ORDINANCE 95-30

TO AMEND THE BLOOMINGTON ZONING MAPS FROM
RS3.5/PRO6 to PUD,
AND APPROVE THE PRELIMINARY PLAN
Re: 2031 S. Weimer Road
(Cora Ann Sudbury, Petitioner)

To: Rodney Young, Plan Commission Members
From: Kevin Komisarcik, Moira Wedekind
Subject: Sudbury Farm PUD
Date: June 21, 1995

PUD-26-95 - CORA ANN SUDBURY
REVIEW CONSIDERATIONS

PUD-26-95
 Site Plan

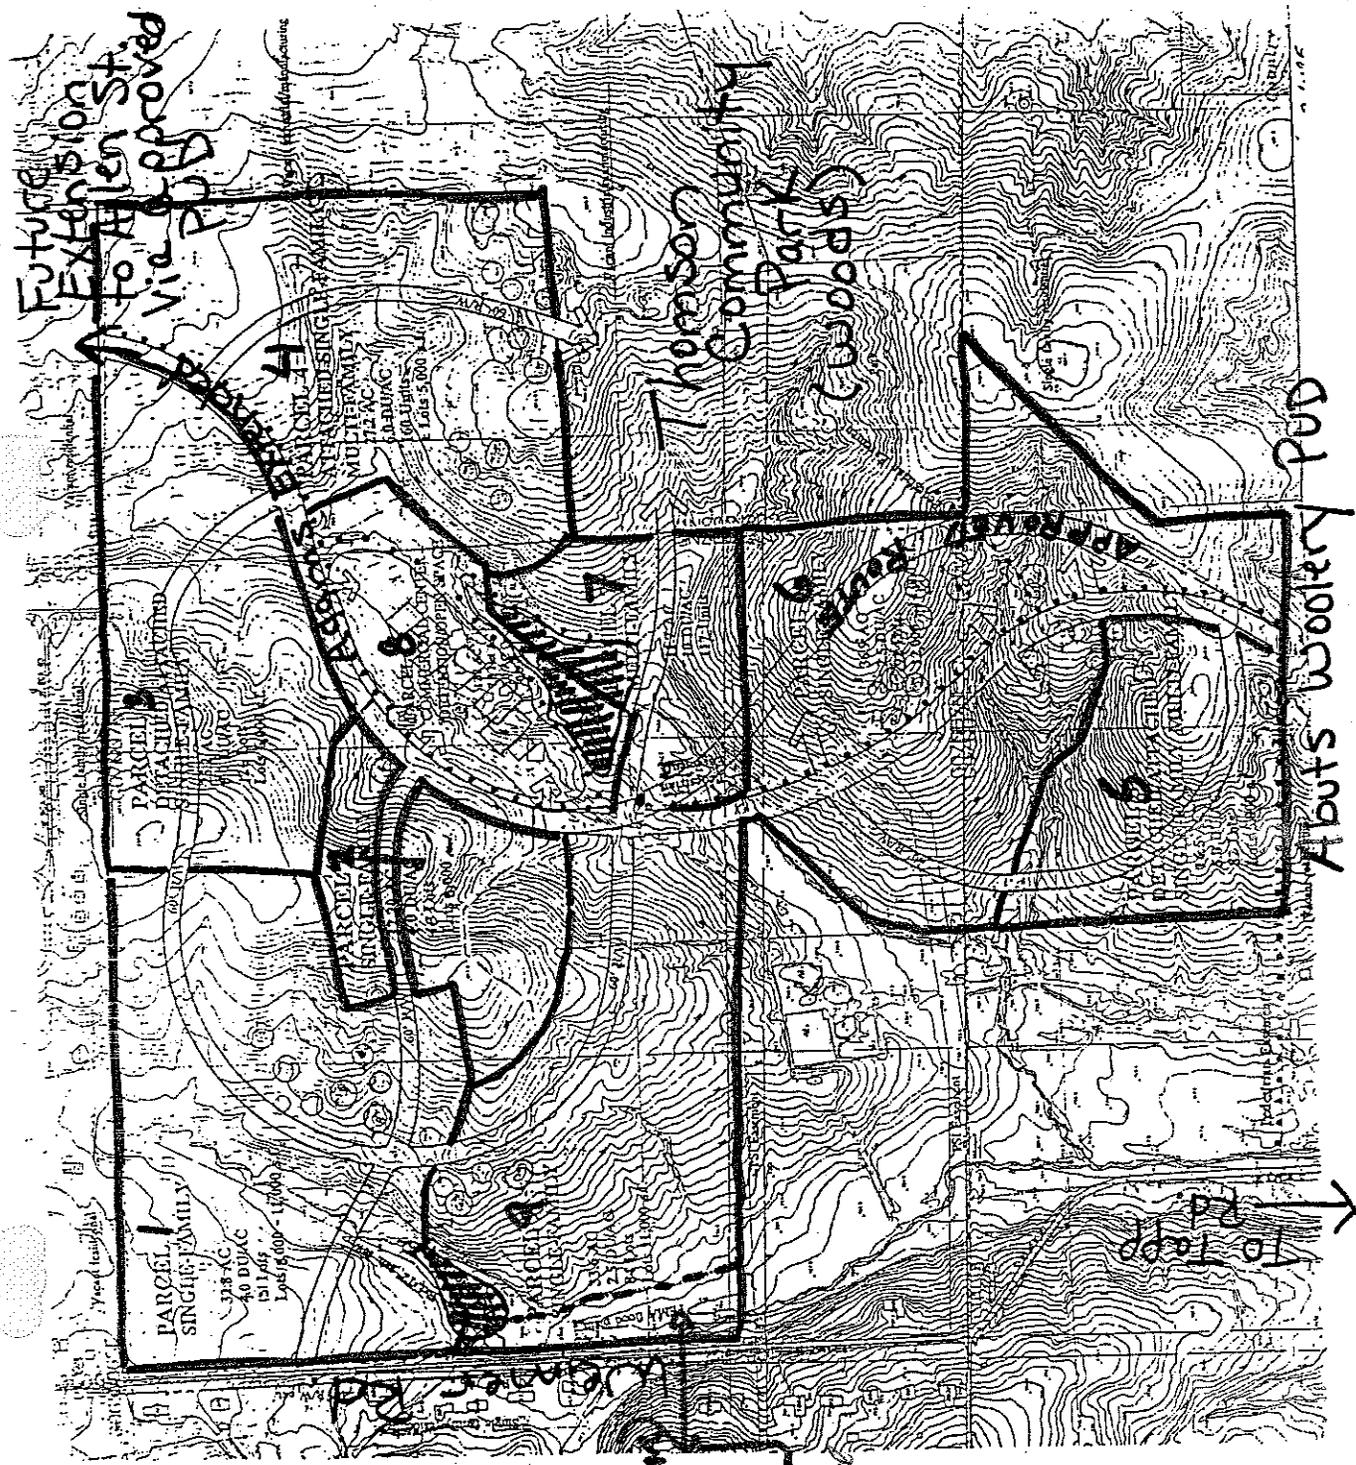
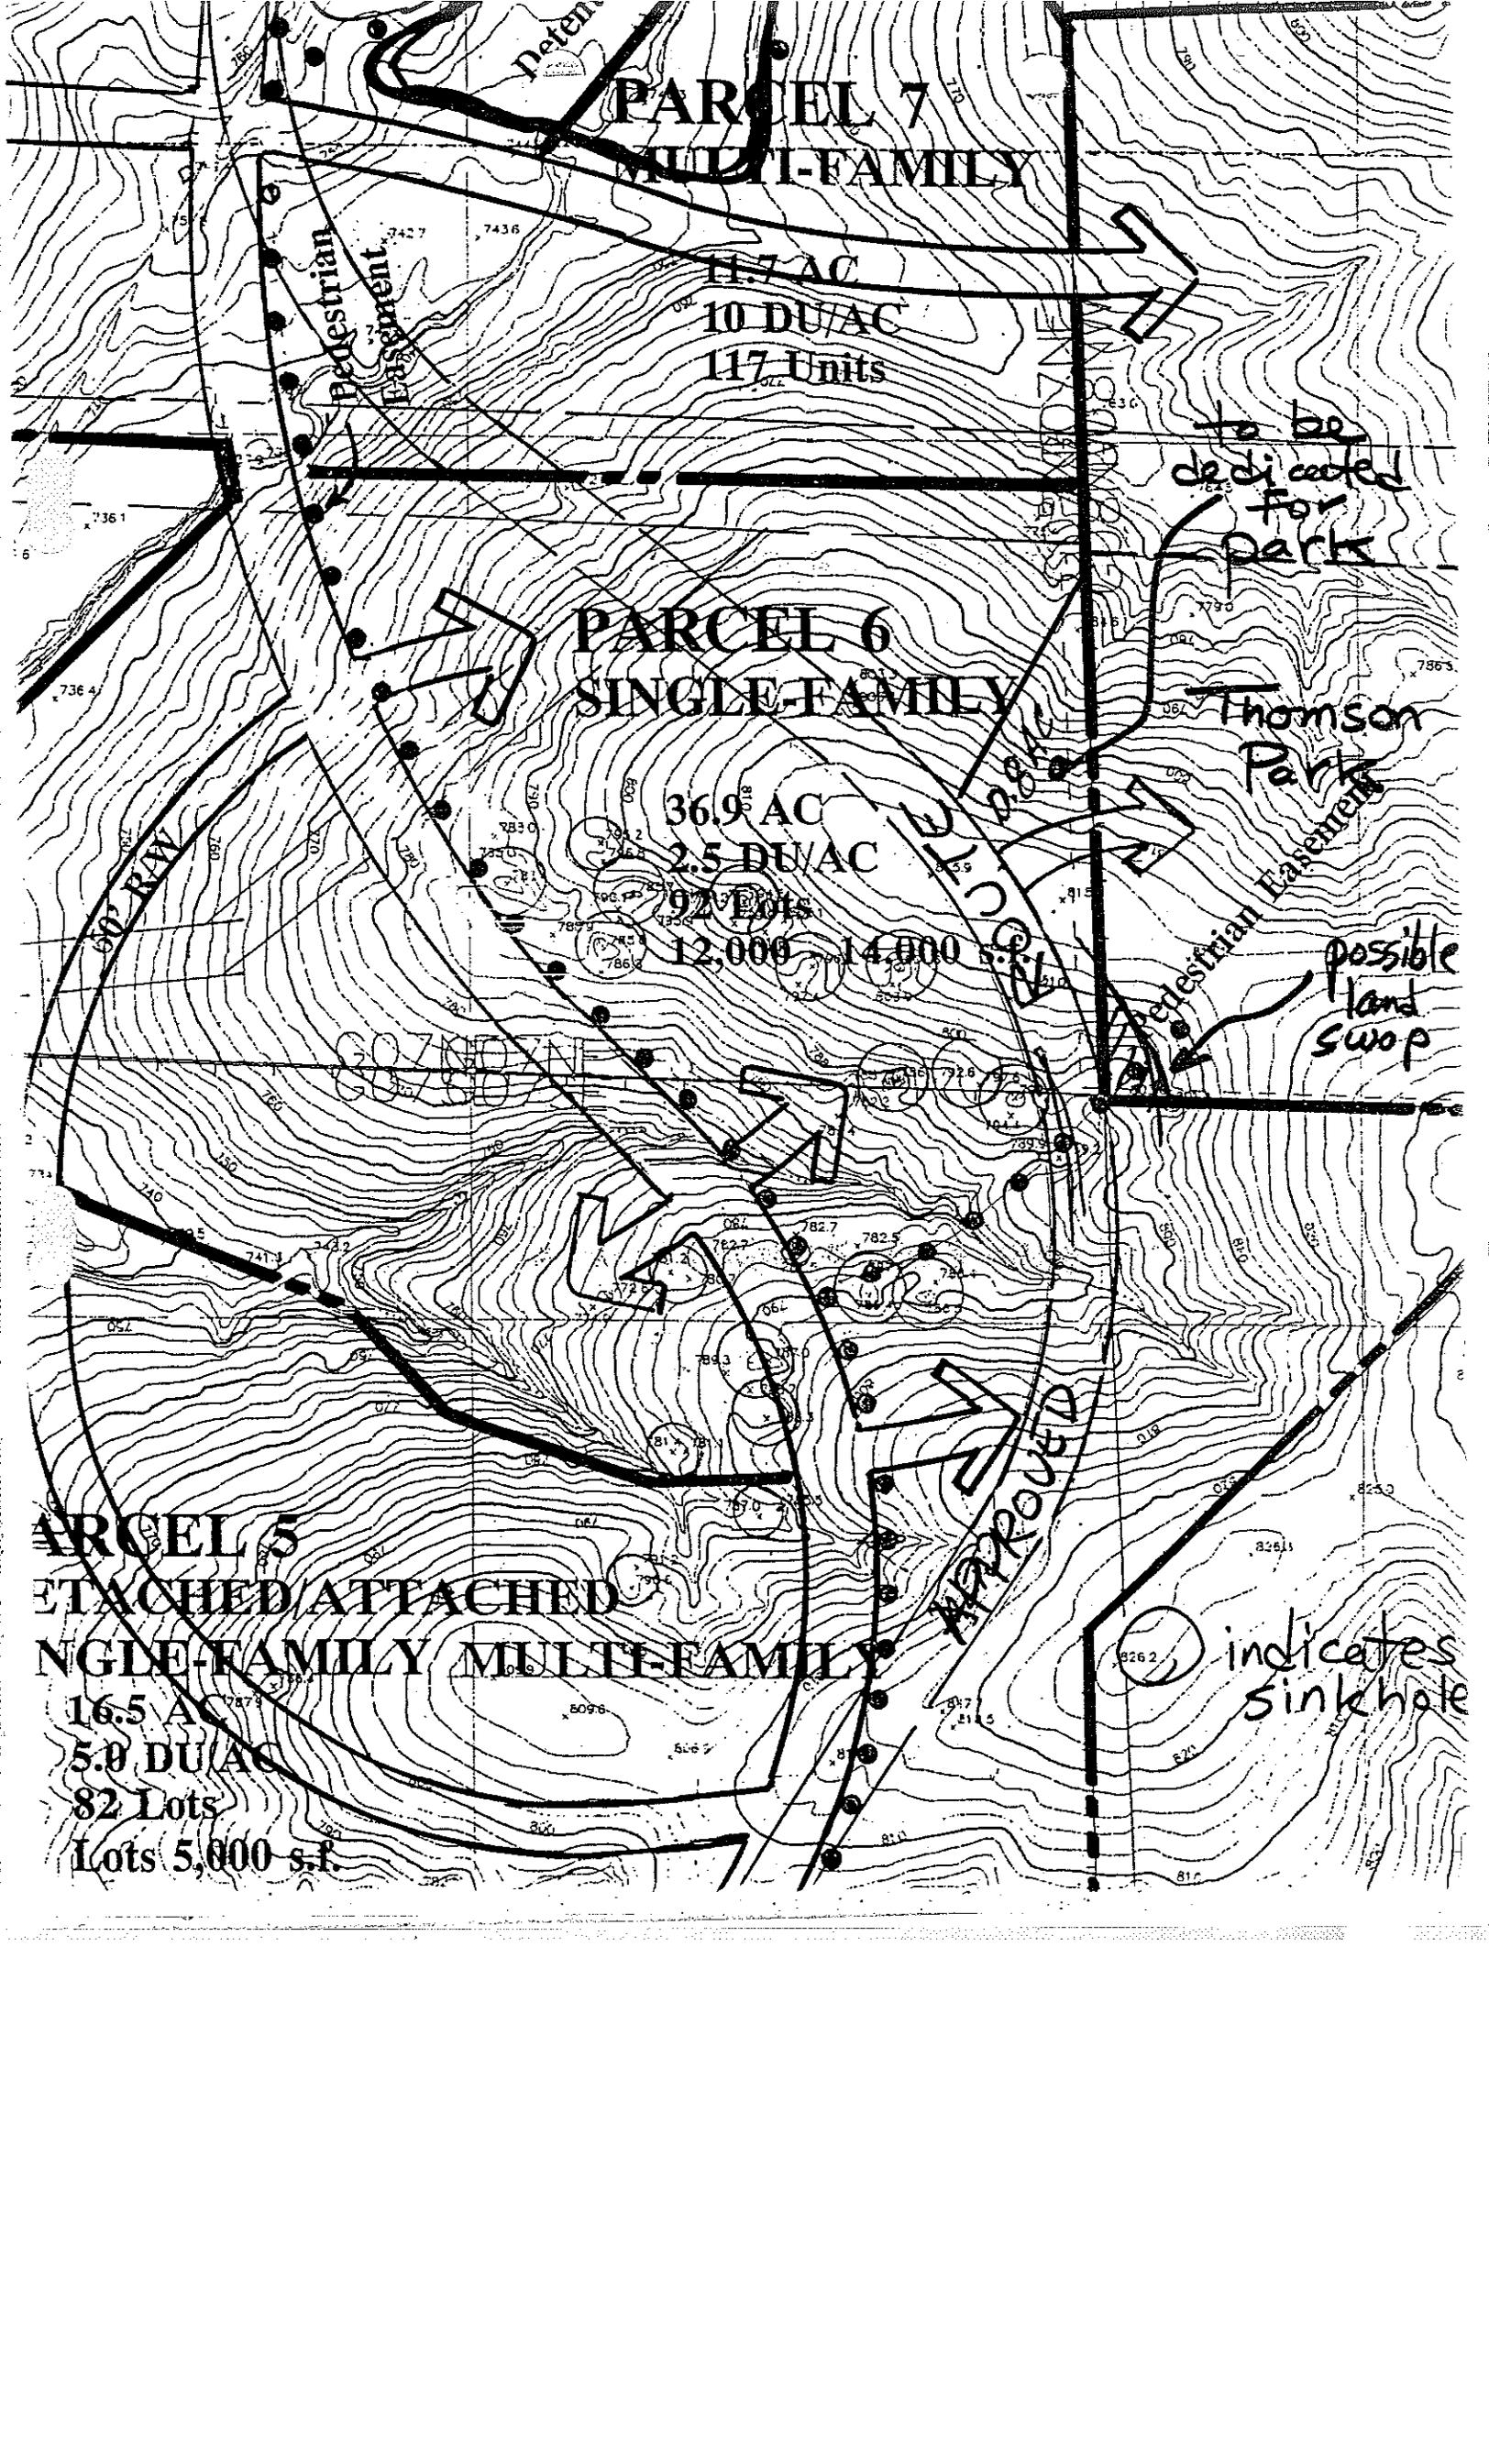
1. The original placement of the main arterial road is not well positioned given the karst features on this property. The road is placed such that it will impact a number of sinkholes on the property. As you know, the new city ordinance prohibits building within 25 feet of such features. We suggest two alternatives:

a. The road be moved towards the eastern boundary where it will be partially adjacent to Thompson Park, affording better access to its' western edge. This is the alternative route shown on the updated map.

b. The road be routed towards the western part of the development where it will be out of the forested area. This would follow the approximate location of the side street also shown on the map.

2. The proposed plan shows a band of higher density development partly in the forested area in the southern part of the site (parcel 5). We recommend that this portion of the development be moved to the non-forested area of the site (the western portions of parcels 5 & 6) and move more of the lower density development in parcel 6 into the woods. In other words the parcels would now align east - west rather than north - south. In this way more of the forest canopy will be saved.

Revised Adams alignment will relate better to sinkholes and grades. Generally, lower residential densities in tree areas will allow more preservation. Expect good detailing of specific preservation in final plans. Environmental Commission subcommittee comment has been considered by the Commission. The road has been revised but land uses remain as proposed.
